Re: Minor Parking Lot Revision and Pavement Plan

From: Andrew Ladyga <atlinvestmentgroupct@gmail.com>
Sent: Thursday, October 2, 2025 12:49 PM
To: Jana Roberson
Cc: Heidi Leech
Subject: (EXTERNAL MESSAGE)Re: (EXTERNAL MESSAGE)Re: (EXTERNAL MESSAGE)2812 Boston Turnpike Driveway Repave and Expansion Plans

From: Todd Penney
Sent: Friday, October 10, 2025 12:43 PM
To: Jana Roberson
Subject: RE: 2812 Boston Turnpike

Original Auto Dealer + Repair Site Plan

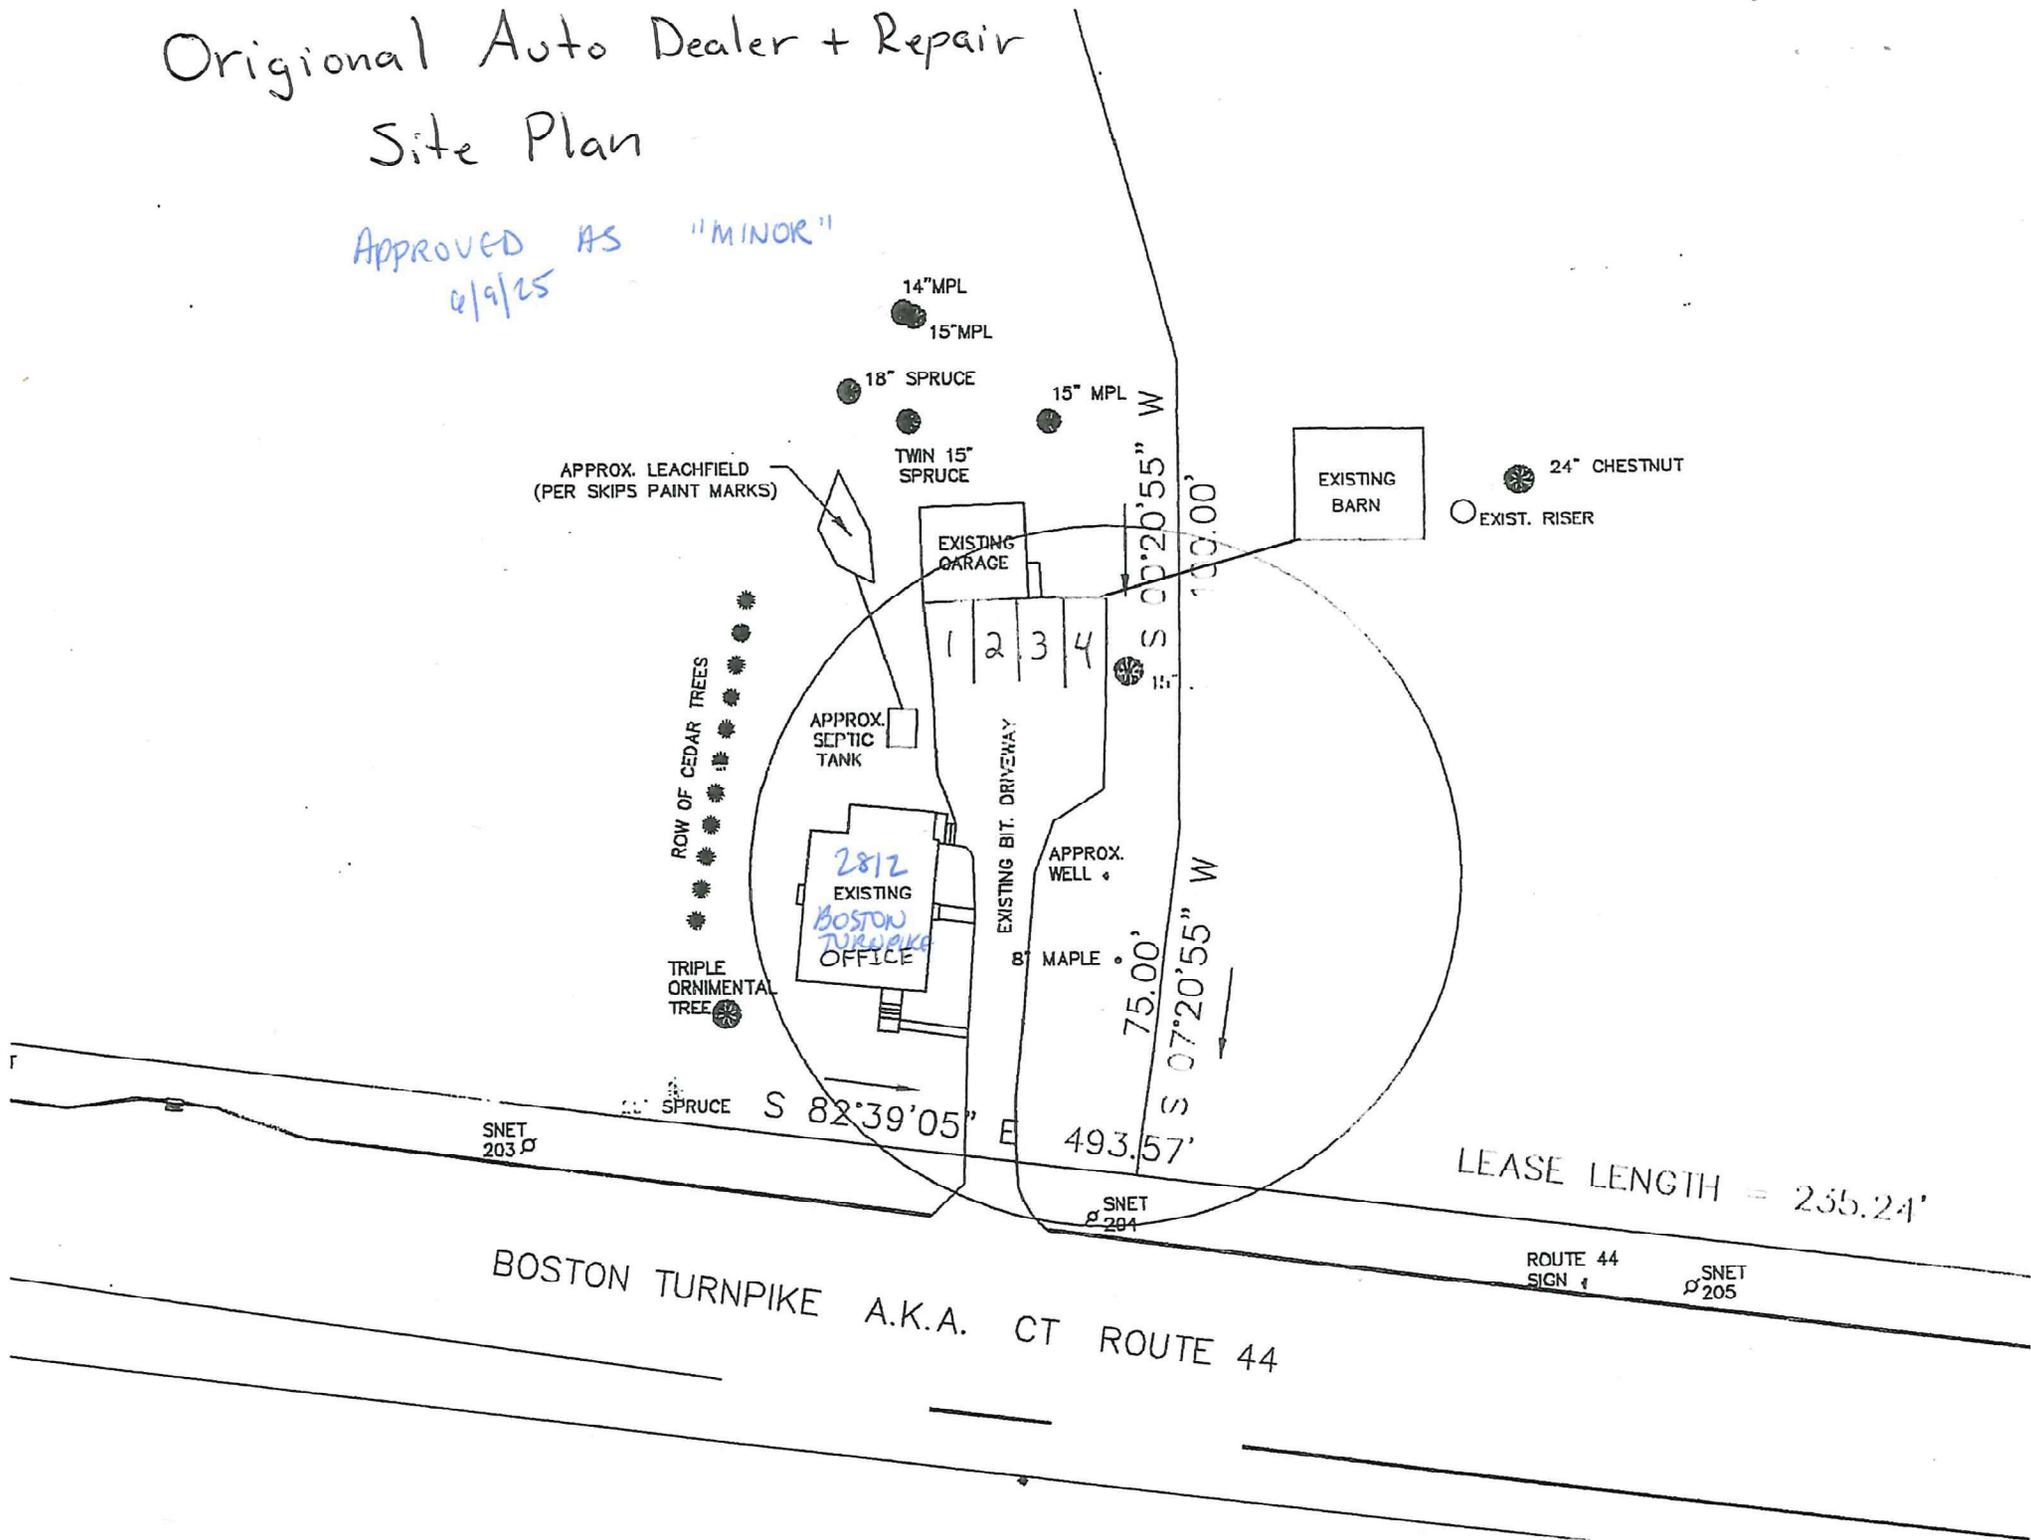
I just want to point out that the final plans you submitted do not match the approved Special Permit plans. See attached. [The recent plans I submitted were for a driveway repair and expansion of our existing residential driveway and we were just looking to get the town's thoughts on how we wanted to organize the driveway and make sure we had all of the proper set back information. This was something we planned to do over a decade ago and came up with a lot design that would incorporate our residential driveway into the commercial phases of the parking lot plans we had approved where phase 1-4 would start and end. Our residential parking area was designed to align with the approved commercial parking lot expansion plans we have so that when the new commercial driveway entrance was opened up and our existing driveway was closed off, we would still have access to our home and parking area.](#)

I am not recommending a site plan waiver this time. [I was not looking for a site plan waiver. When I reached out to you and the town engineers, it was to get some preliminary thoughts and information on moving some of our parking spaces around once we had our driveway repaired and paved. Over the last 3-4 weeks I have met with 4 different paving companies to get their recommendations and prices on repairing our damaged driveway, removing the dead stump and roots under our driveway, and expanding our driveway so we had some additional room and would no longer need to park on the grass. All of the paving companies I met with suggested the same driveway layout and told me I had plenty of room to pave this area and this plan was compliant with Convetry's regulations. This is when I also reached out to you and everyone in the engineering department to confirm we had all of the correct setbacks and met the town's driveway regulations. I also went through all of the zoning regulations myself to make sure we meet all of the lot coverages and our driveway expansion plans were compliant. The maximum lot coverages I found in the zoning regulations were as follows: Residential GR 80 lot coverage is 15% and Commercial lot coverage is 60%.](#)

Any reason not to implement the actual approved site plan in phases? One of the main reasons why we don't want to expand our driveway and parking lot over to the area where phase 1 begins is due to the substantial cost difference between repaving our current driveway and constructing phase 1-4 of our parking lot plan. The cost to repair, and expand our existing driveway has been estimated to be around \$40,000 while just constructing phase 1 of our parking lot plan is estimated to cost around \$200,000 and would only give us 4 additional parking spaces. The additional \$160,000 needed for an additional 4 parking spaces is not worth the extra expense and the cost increase is due to all of the additional infrastructure needed to open up and construct an entirely new commercial driveway entrance, installing underground drainage systems, catch basins, detention ponds, storm sewer tie ins, rain gardens, and underground utilities. All of the additional construction costs and site work needed for the commercial phases of construction would be a waste of money and would not be needed since our residential driveway will not extend into the commercial area of phase 1. The full cost to construct the entire commercial parking lot was estimated to be around \$300k - \$350k and is something my wife and I do not have a need for or the desire to do at this time. We also do not need this much parking for our residential and business needs and if we constructed a parking lot of this size today, it would sit 100% vacant. I also know and understand that if we ever intend to expand my residential driveway into the commercial parking area where phase 1 has been planned and approved, we would need to complete all of the additional site work described above.

Thank you for the opportunity to review and comment on the pending waiver for engineered site plan. While I understand the owner/applicant is trying to minimize its exposure to costs, I am not in favor of the waiver:

* as improvements to the existing driveway needs to be made to accommodate two-way traffic with the additional parking spaces requested and potential conflicting traffic in and out of the property. (Encroachment Permit from CDOT will be required for said activity.

* Additional impervious lot coverage will need analysis for stormwater runoff and what mitigation might be required.

Revised Parking Area

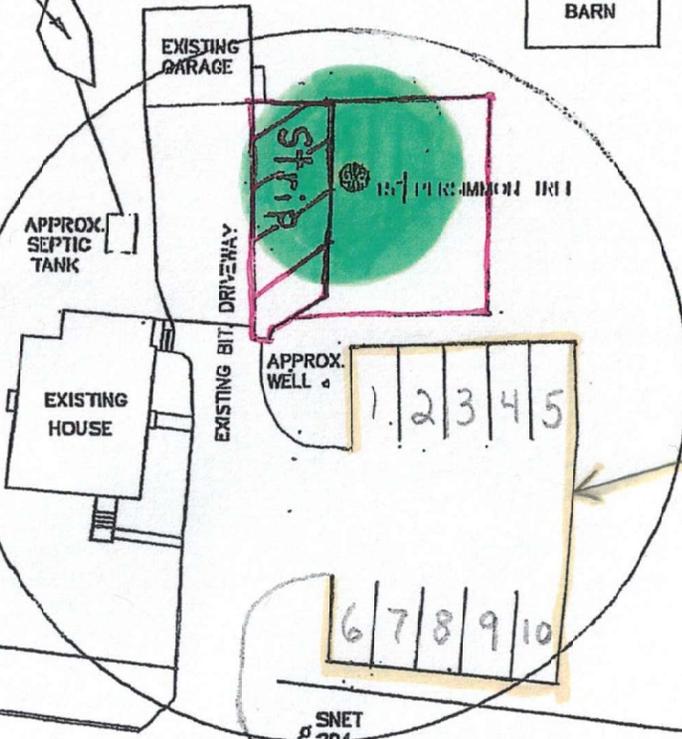
Here are the driveway repair and parking lot relocation plans we have been working on with our paving contractor. This minor revision shows how we are looking to move our parking area forward and how we would like to repave the damaged area and organize our lot. The paving company we are currently working with explained that in order to fix our parking lot correctly, I would need to remove the large tree stump and root system that is currently under our driveway and outlined on the site map in green where parking spaces 3 & 4 currently are. The paving company has proposed removing the broken asphalt & tree stump and filling this area in so it can be leveled and compacted so it will not crack apart again. After reviewing the parking plan, the paving company recommended moving my current parking lot forward where the residential parking spaces numbered 50-55 have already been approved years ago. Having over 8 acres of land and only four total parking spaces available to use restricts our parking area and has reduced the parking availability for friends, family and guests to less than we had in the past. Having the ability to make this minor adjustment to our driveway and parking area will give us the room needed so we no longer have to park any personal vehicles on the grass and will allow everyone easier access in and out of the property. This will also give the paving contractor the ability to fix and repair the damaged parking area where the stump and roots are while allowing the necessary time for soils to settle and compact.

The paving company we are working with drafted up a driveway repair and expansion plan that works well and incorporates the four current residential/commercial parking spaces we have along with the additional six residential spaces we were previously approved for in the past using the parking spaces numbered 50-55 on our current auto dealership site plan. Our goal would be to use the area up front for our parking/display area and our parking plan has been designed so it lines up perfectly with our current approved auto dealership expansion plans we have for the future. The driveway extension and repair plan was also designed so that the existing residential driveway would remain in use until the new commercial entrance and 45 additional parking spaces were needed for business expansion. The revised parking area was also designed so it would not extend past the approved residential parking area and would not go into the main commercial parking lot where parking spaces 49 & 5 begin. I have outlined these spaces on our approved site plan for your reference.
